David Garrett, P.G.
Engineering Geologist

October 4, 1999

**RE: Evaluation of Potential Impact on Landfill
Proposed Martin Marietta Aggregates Quarry
High Point, North Carolina**

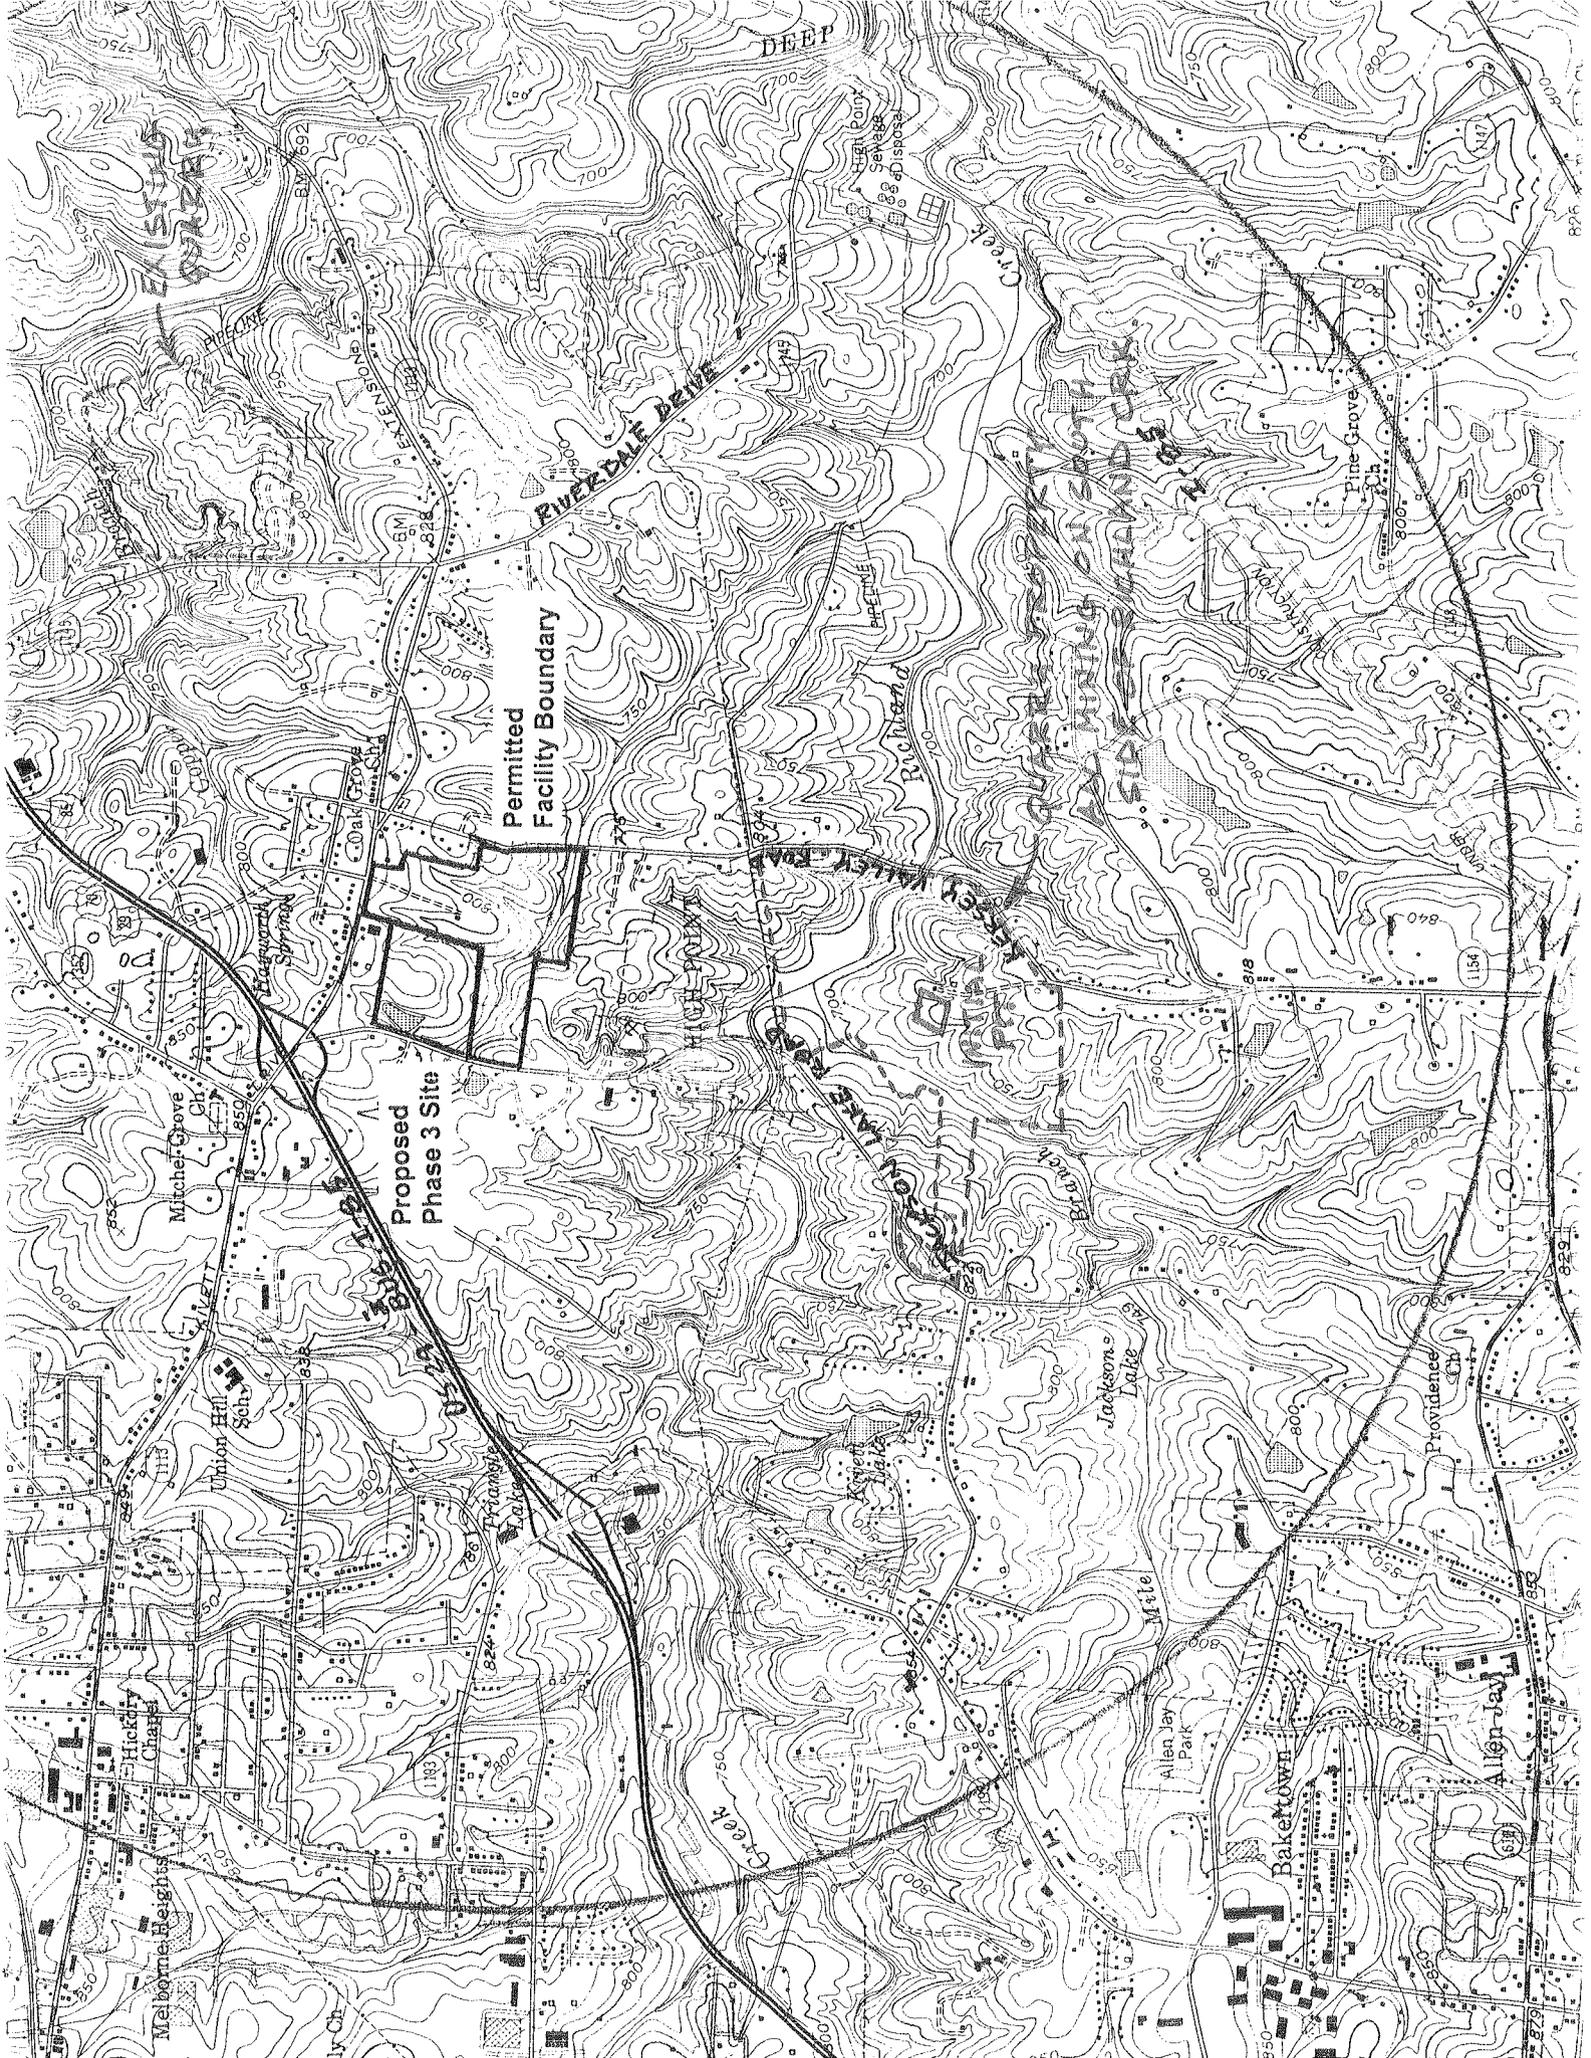
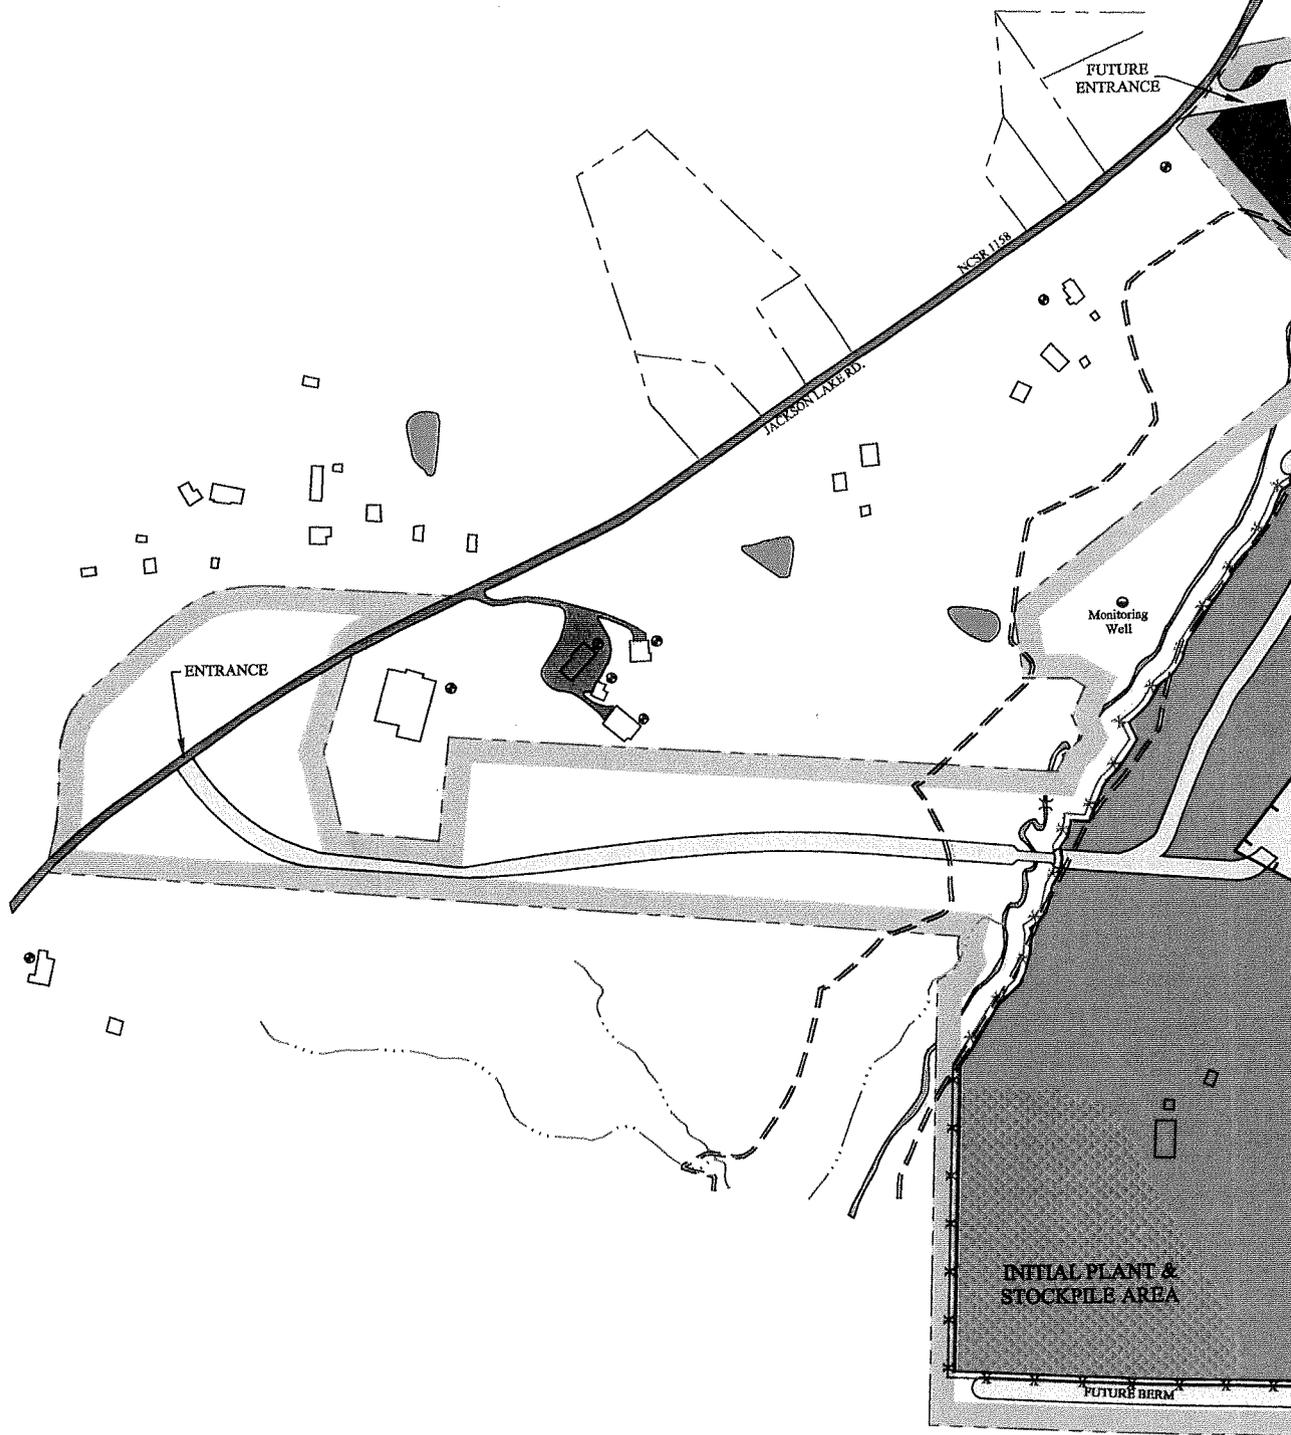
Please refer to the area topographic map, copied from the City's permit application for the Kersey Valley Landfill Phase 3. The planned quarry is located about 0.6 miles south of the landfill, between Jackson Lake Road and Kersey Valley Road. In plan view, the proposed quarry will be equidistant from the landfill as the existing Jamestown quarry, located northeast of the landfill on Riverdale Drive. This new site was originally permitted in 1989 by the Nello Teer Company, now Benchmark Corporation (Permit #41-18). The permit has now been transferred to Martin Marietta Aggregates.

Martin Marietta Aggregates		
RALEIGH, N.C.		
SITE PLAN		
HIGH POINT QUARRY GUILFORD COUNTY, N.C.		
QUARRY:	HIGH POINT	
DWN'D BY:	D. BRIGHT	DATE: 7/18/99
		Page No.

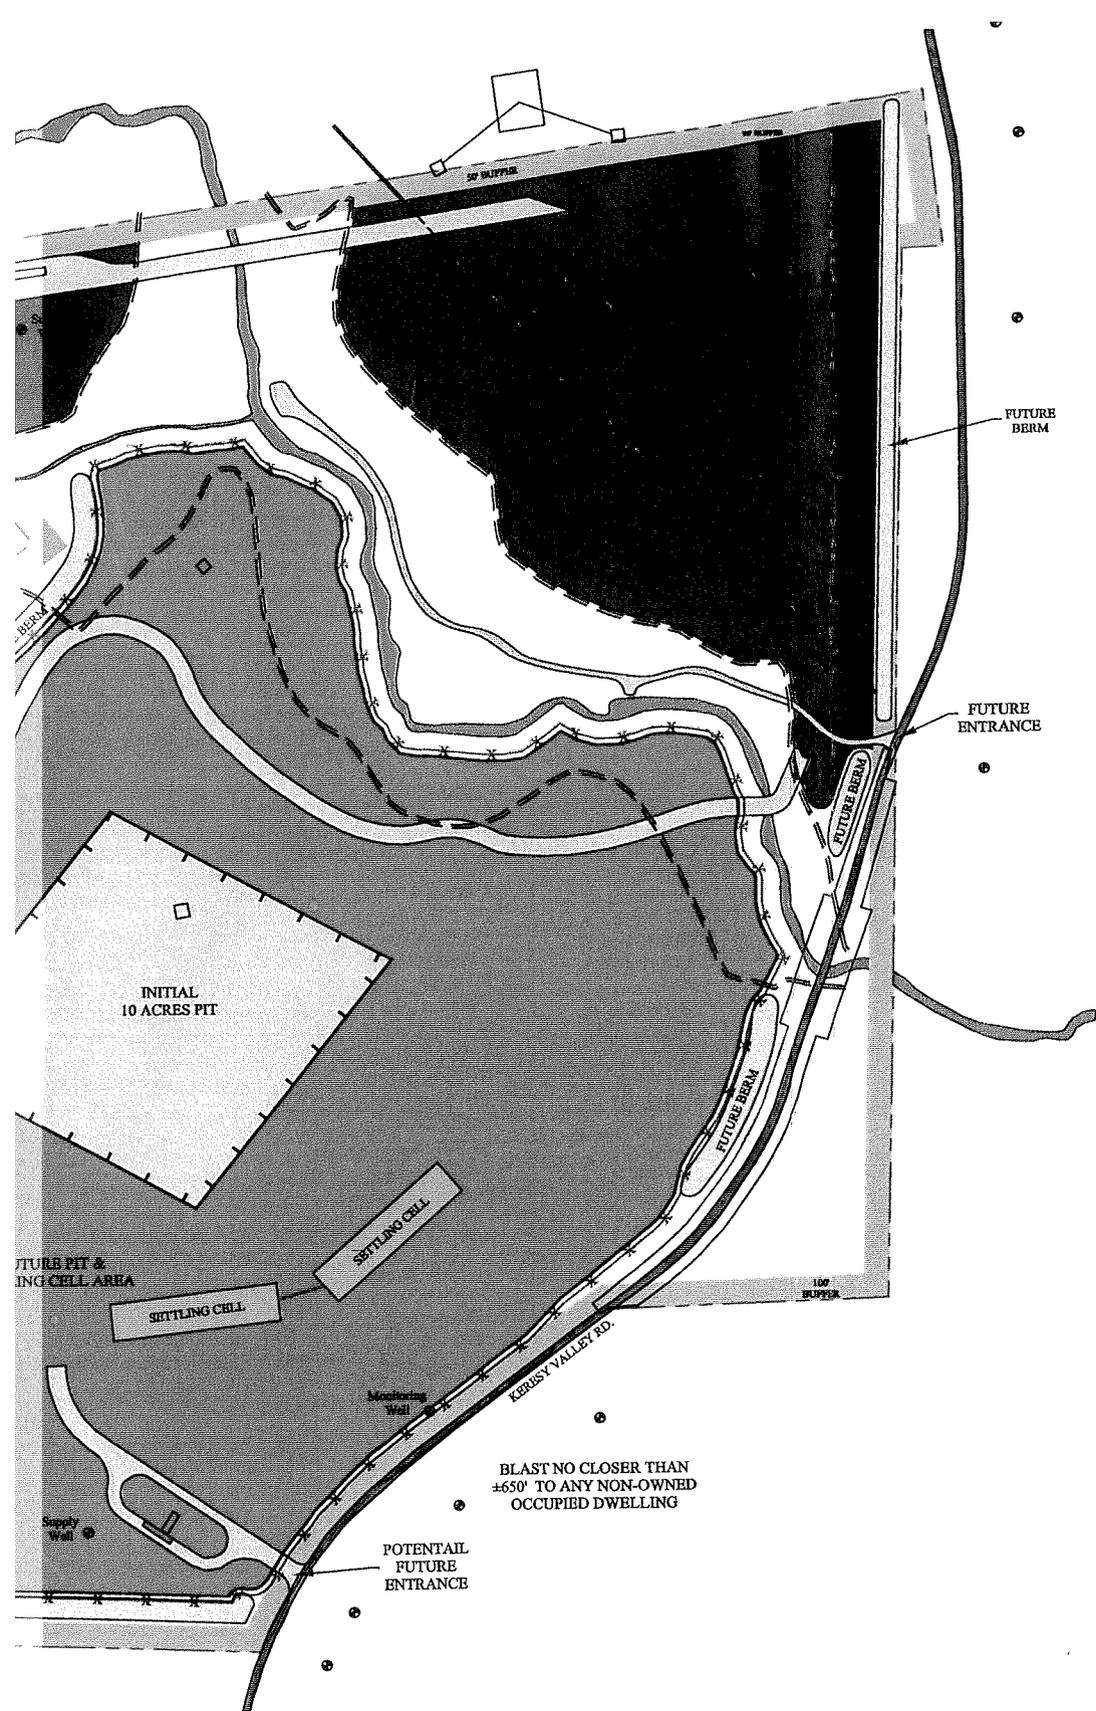
The attached color map furnished by Martin Marietta shows the current development plan. The quarry property covers about 180 acres, but the actual disturbed area was cited in one of the older permit file documents as less than 60 acres. The actual mine pit will be south of Richland Creek, a local ground water discharge feature. Initially, a 10-acre pit will be opened in the center of the site, and a temporary crusher mill will be located in the southwest corner of the property next to Jackson Lake Road. A permanent crusher mill may eventually be built on a portion of the property north of Richland Creek, utilizing a conveyor system between the mine pit and the processing area.

The mine is planned to be approximately 200 feet deep at the center. Access is currently planned to be limited to Jackson Lake Road (verbal information), although the plan map shows future access to Kersey Valley Road, as well. The planned US 311 Bypass will pass just south of the planned quarry. The rock type is granite. Mr. Badham indicated that the mine may not be opened for 10 to 12 years, as it will serve as a replacement for the existing Jamestown Quarry on Riverdale Road.
